Appendix 1-2 Initial Study/Mitigated Negative Declaration Response to Comments

May 2020 | Response to Comments on Mitigated Negative Declaration
SCH # 2020029070

DEL MAR HEIGHTS SCHOOL REBUILD PROJECT

Del Mar Union School District

Figure 1 - Site Plan Comparison
2. Response to Comments

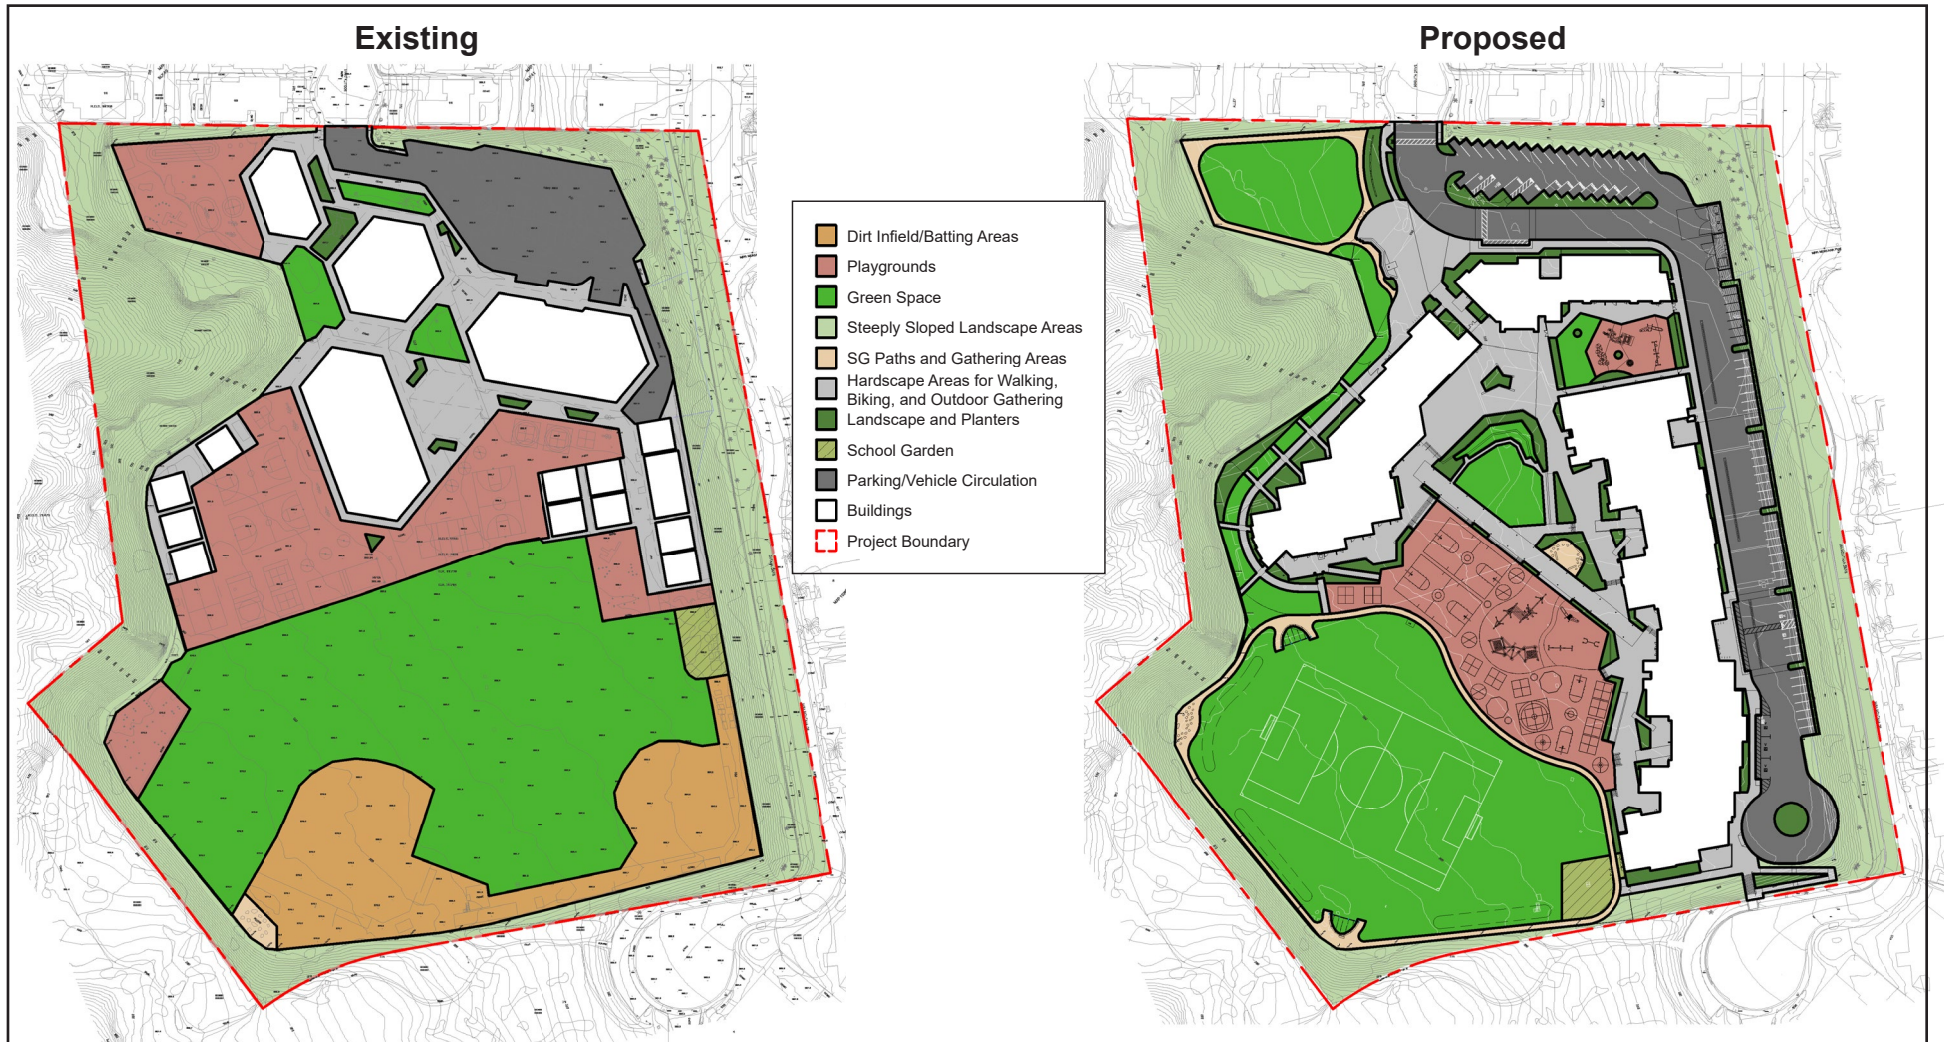
The program developed by the project architects in close consultation with the District and through a series of public meetings is presented in Figure 1, *Site Plan Comparison* and Table 1. This figure and table provide a comparison of the proposed plan with the existing campus. Figure 1 is included here to provide an accurate comparison of how the total site area is used under both existing and proposed plans. The District developed the proposed site plan to achieve its education goals, minimize vehicular congestion, improve pedestrian safety, respect neighborhood views and improve emergency vehicle access. Accomplishing the District's educational and site goals resulted in modifying the green space and play areas as shown in Table 2.

Figure 3 - Student Access Plan
2. Response to Comments

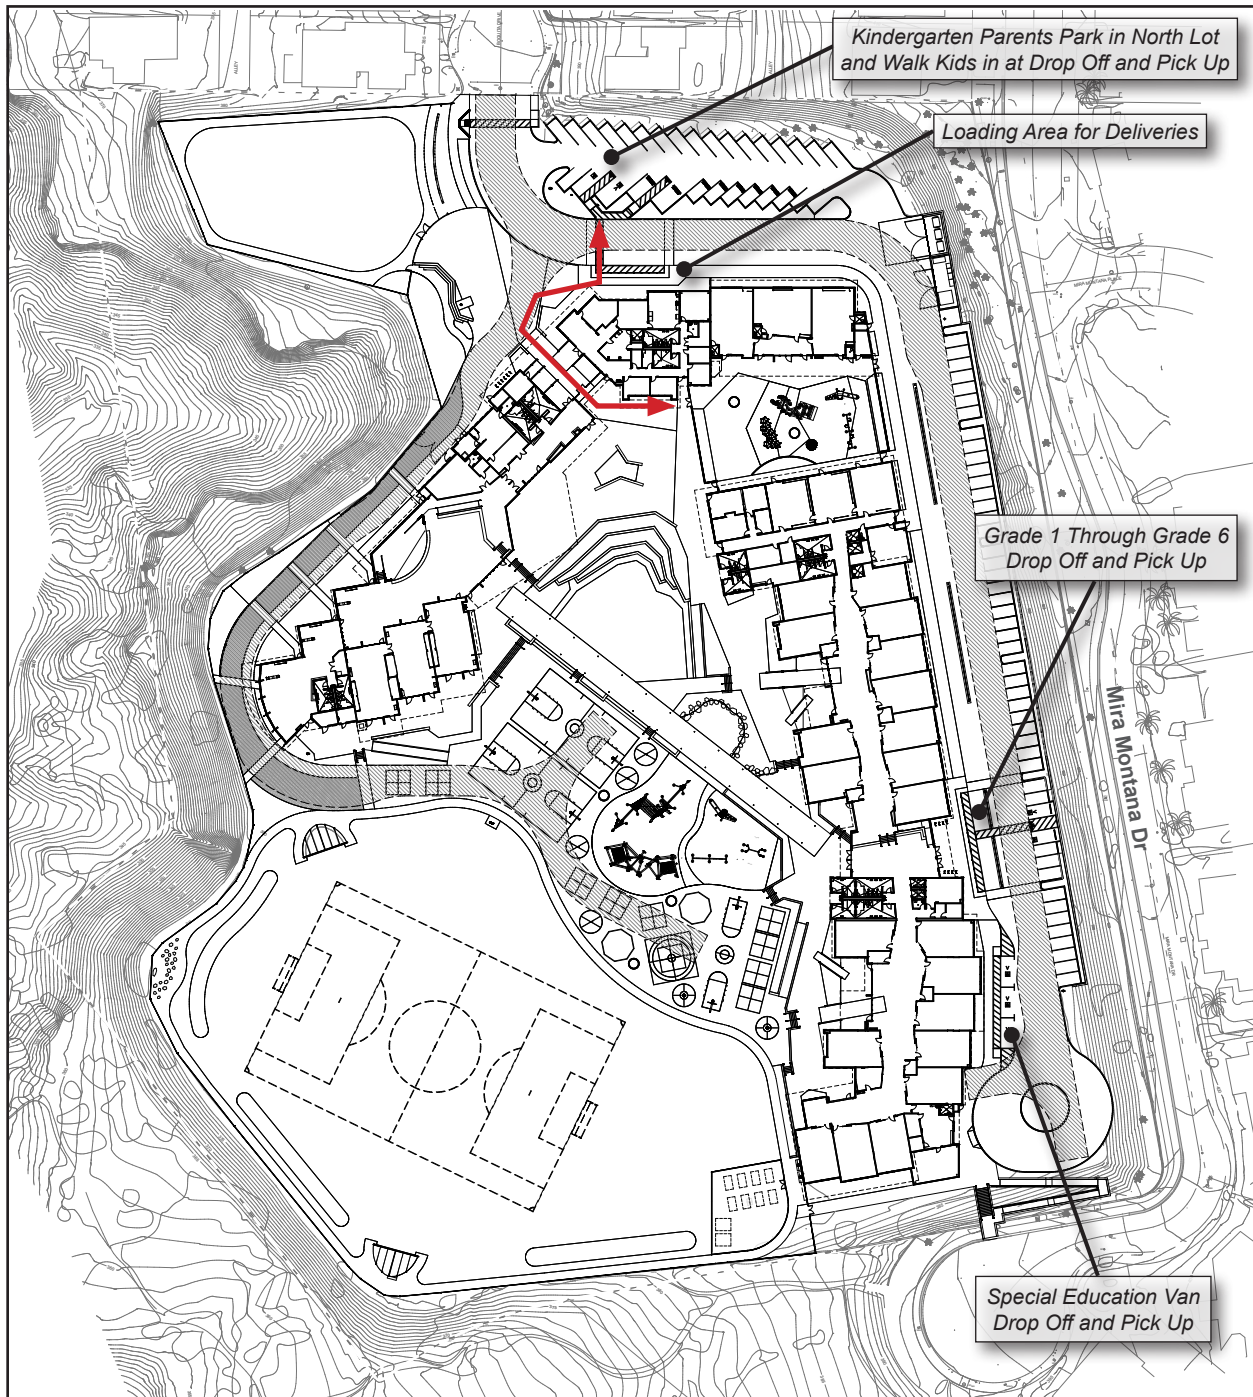
Several comments stated that the proposed access plan would create greater congestion, encourage more driving, discourage biking and walking to school, and create more noise and air pollution. Figure 3, *Student Access Plan* provides more detail about the access plan and identifies where drop-offs/pick-ups will occur by grade level and special education.

Figure 4 - Fencing Plan
2. Response to Comments

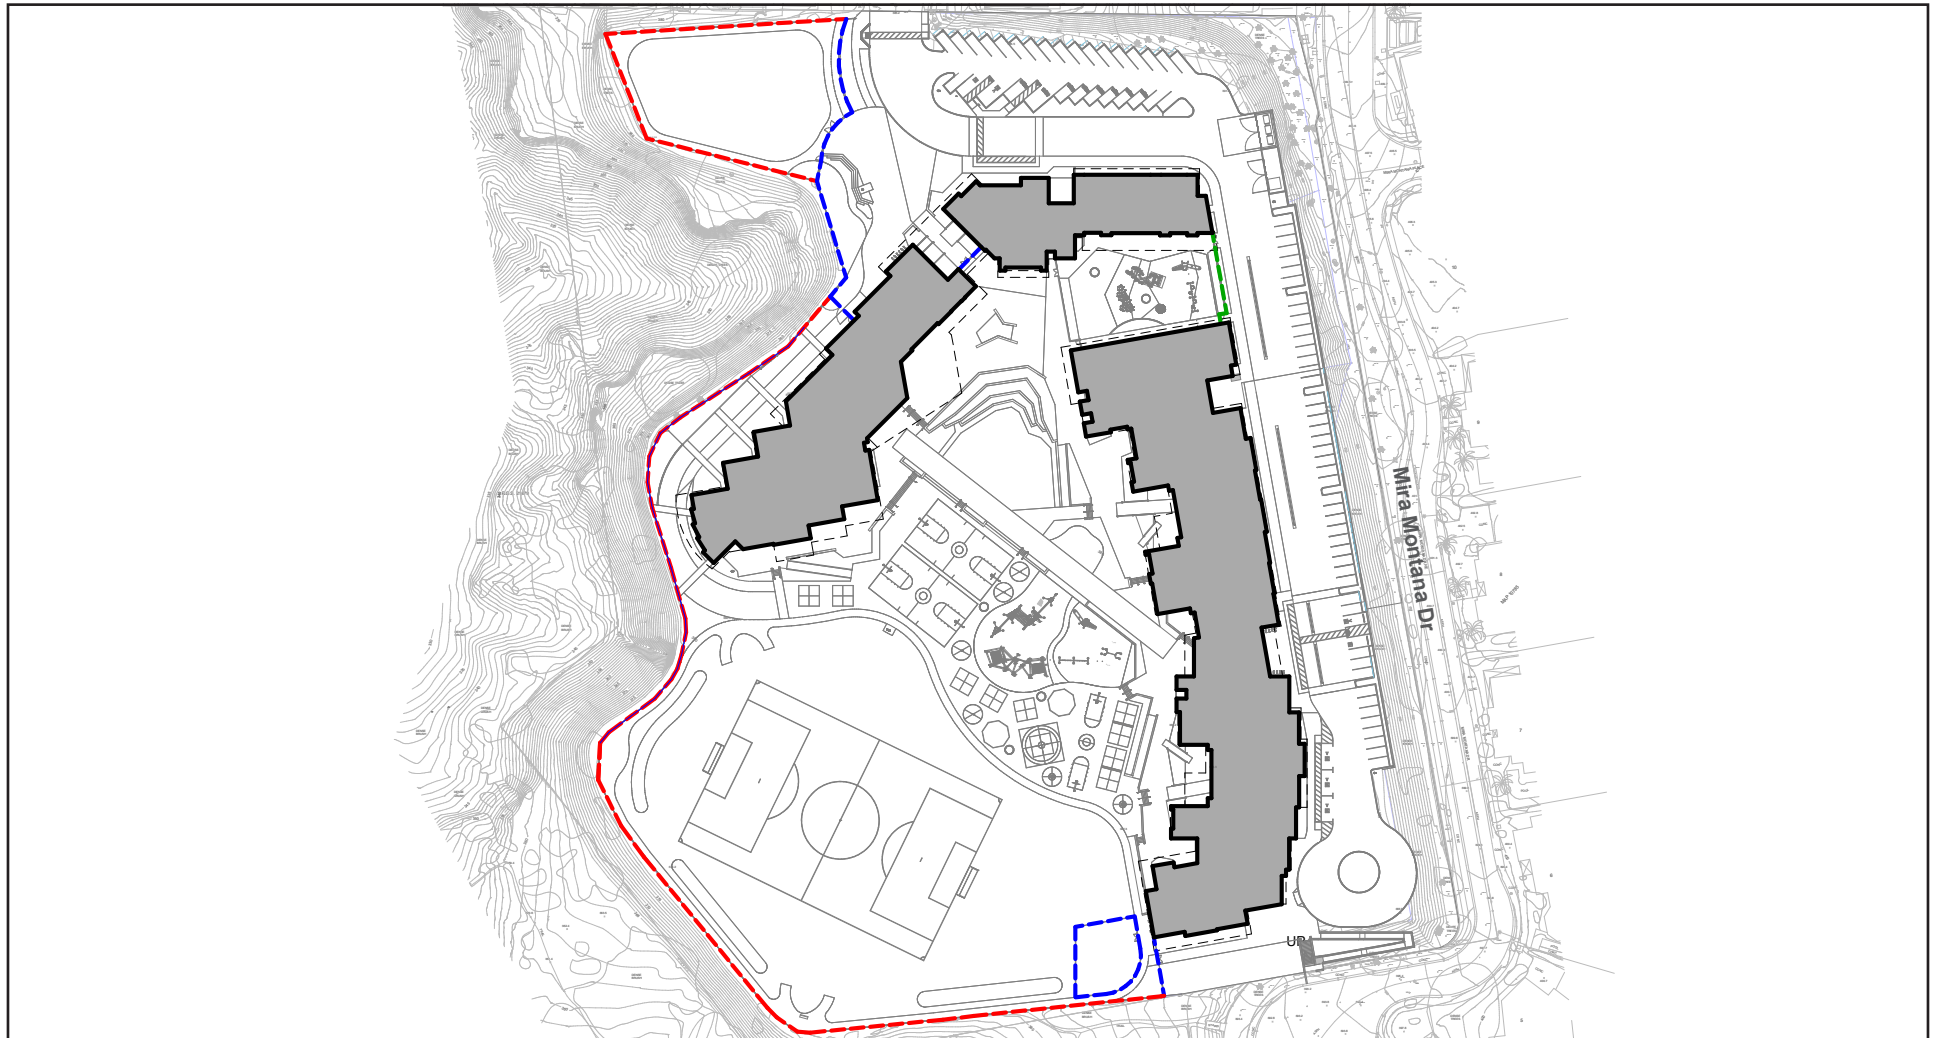
Several comments were received stating that access to the campus would be prohibited after completion of the project. The comments are not correct and there is no evidence to support these statements. The District's plan includes fencing and gates, but this is to provide needed security for students and staff during the school day (see Figure 4, *Fencing Plan*). The campus is currently fenced and public access to the site is prohibited during school hours.

- B-5 The existing campus has a 6-foot tall chain-link fence along the perimeter of the campus, including the edge of the canyon. No changes are proposed for this fence. There would be no direct access points to the buffer area or the Reserve from the west side of the school campus (see Figure 6. *Fencing Plan*). The project does not create any new access to the Reserve trail system. Current access is via a dirt path, which is associated with continued erosion and indirect impacts to the Reserve. The project repairs and protects against the potential indirect impacts.

Figure 5 - Fire Access Lane
2. Response to Comments

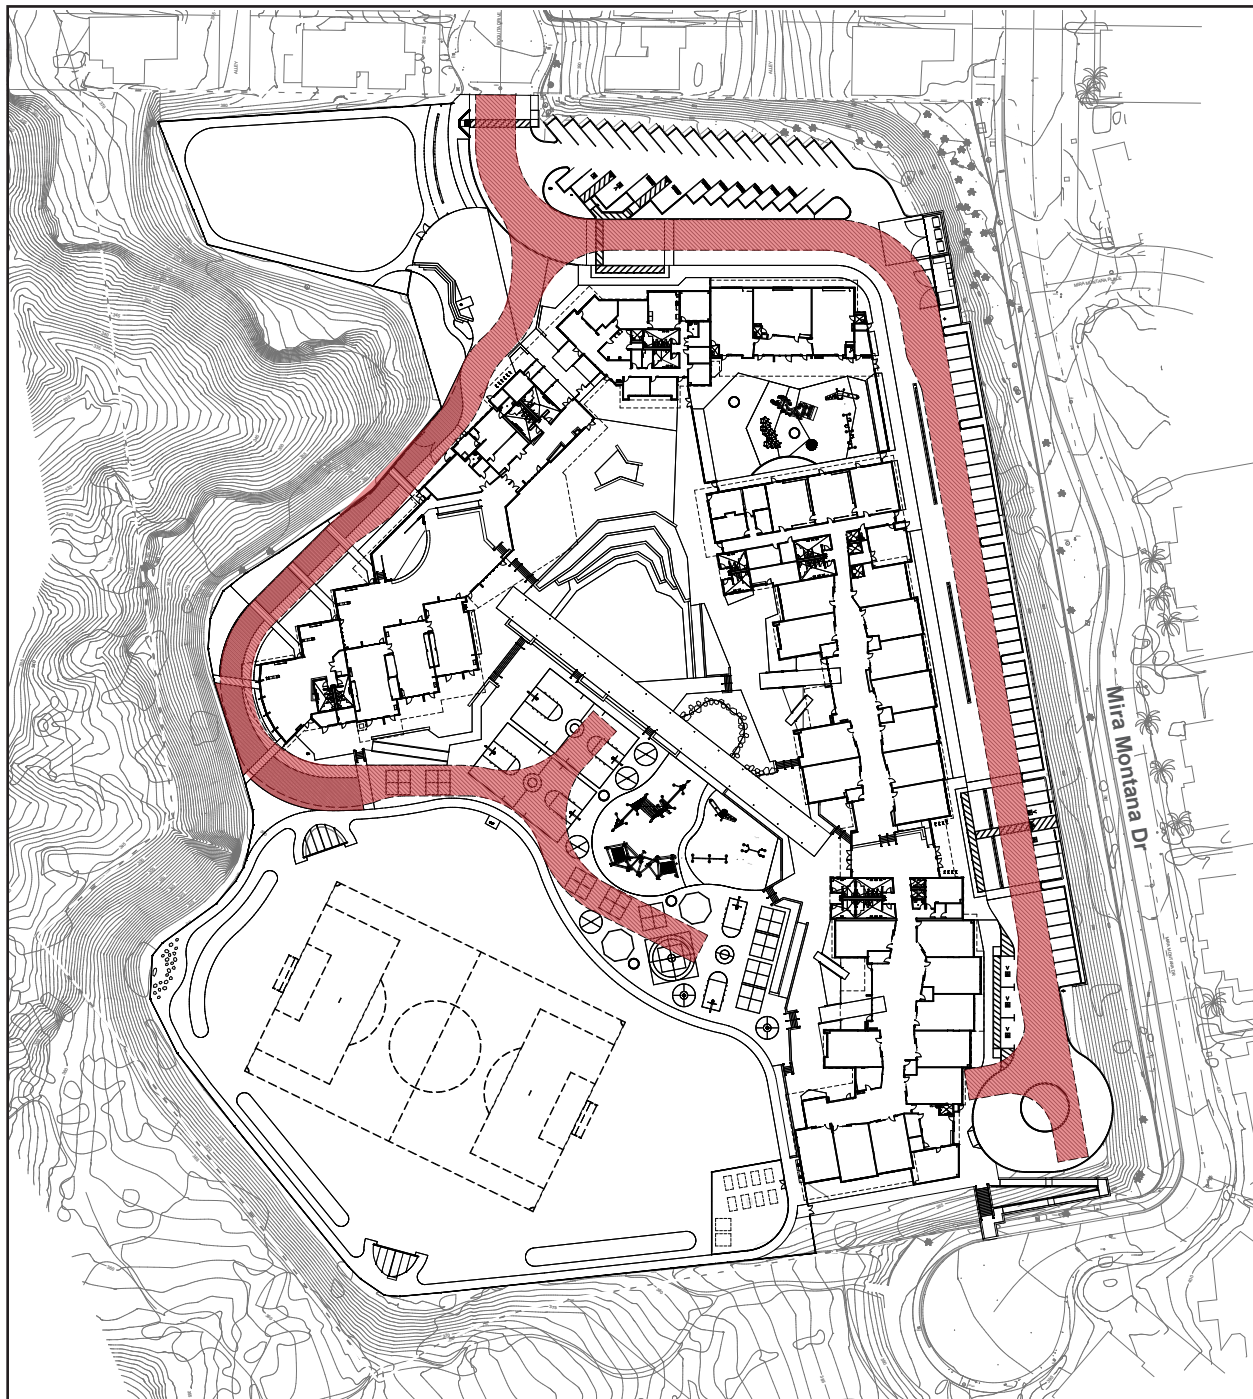
Comments were received concerning the adequacy of the fire lane. Figure 5, *Fire Access Lane*, is included here to ensure an understanding of its location on the site.

The existing fire access lane is inadequate as the width of the lane is only 10 feet between the edge of the slope and the building. The minimum width is 20 feet per the 2019 California Fire Code. The proposed fire lane is 20 feet in width throughout its length and it eliminates the existing restricted access point (see Figure 7, *Fire Access Lane*). The fire lane includes hammerhead turnarounds and the hose length distances are in compliance with the 2019 California Fire Code. Further, the plan has been reviewed and pre-approved by the City of San Diego Fire Marshall.

- J-12 Refer to Figure 7, *Fire Access Lane*, in Master Response 2.1.1, *Project Description*, which is included clarify the fire access lane's location on campus. The proposed fire lane is 20 feet wide along its entire length and eliminates the existing restricted access point. The fire lane includes hammerhead turnarounds and the hose length distances are in compliance with the 2019 California Fire Code, meaning they provide access to all buildings. Further, the plan has been reviewed and pre-approved by the City of San Diego Fire Marshall.

Figure 8 - Comparison of Campus Areas by Type
2. Response to Comments

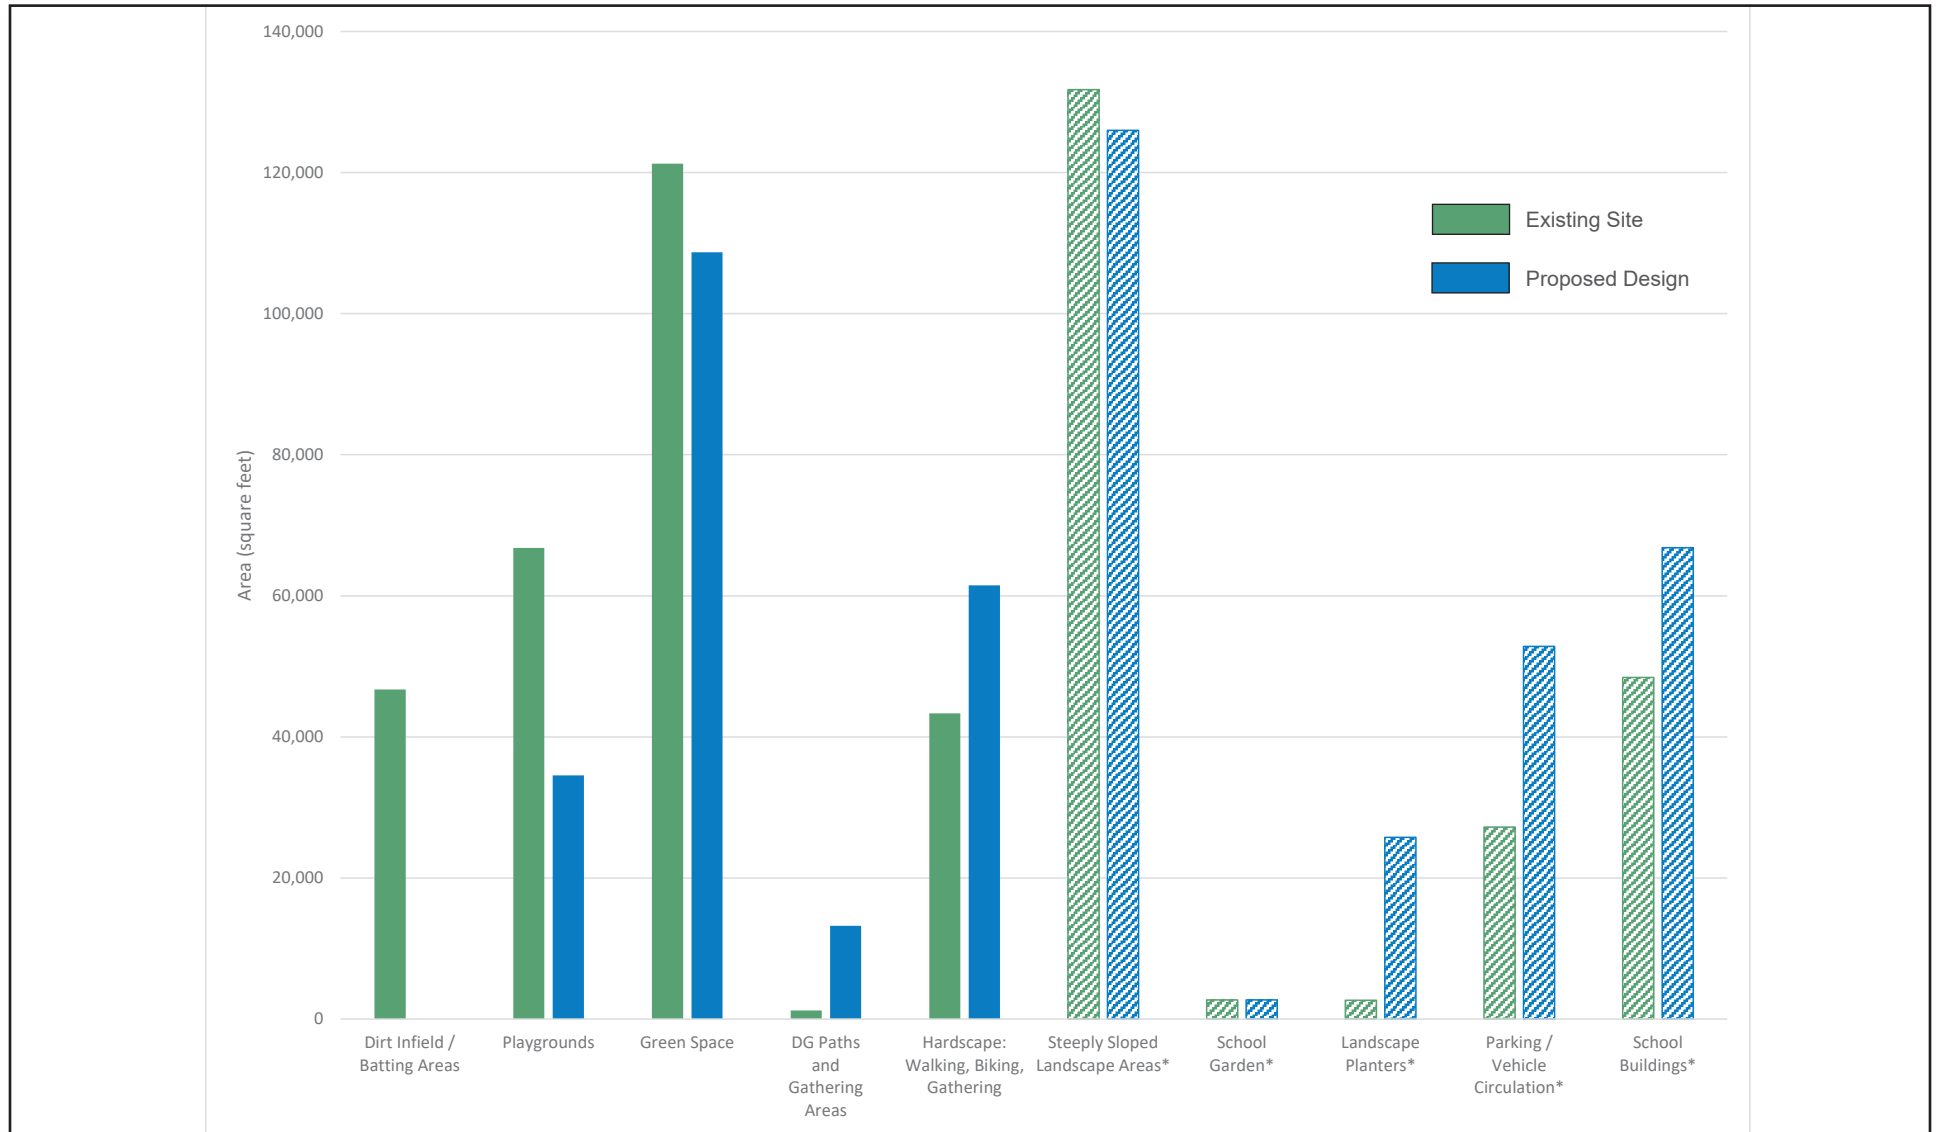
Compared to the existing campus, the proposed design has less dirt infield, playground, green space and steeply sloped areas. The proposed design has more decomposed granite paths/gathering areas, hardscape, landscape planters, parking/vehicular circulation and school buildings. The area dedicated to the school garden is similar. See Figure 8.

- J-29 See responses to J-28.
- J-30-31 The District asserts that the loss of recreational space has been overstated as demonstrated through views of Figure 3, *Open/Community Accessible Areas*, Figure 8, *Comparison of Community Accessible Areas by Type*. Although the amount of useable recreation space would decrease under the proposed plan, the project also includes
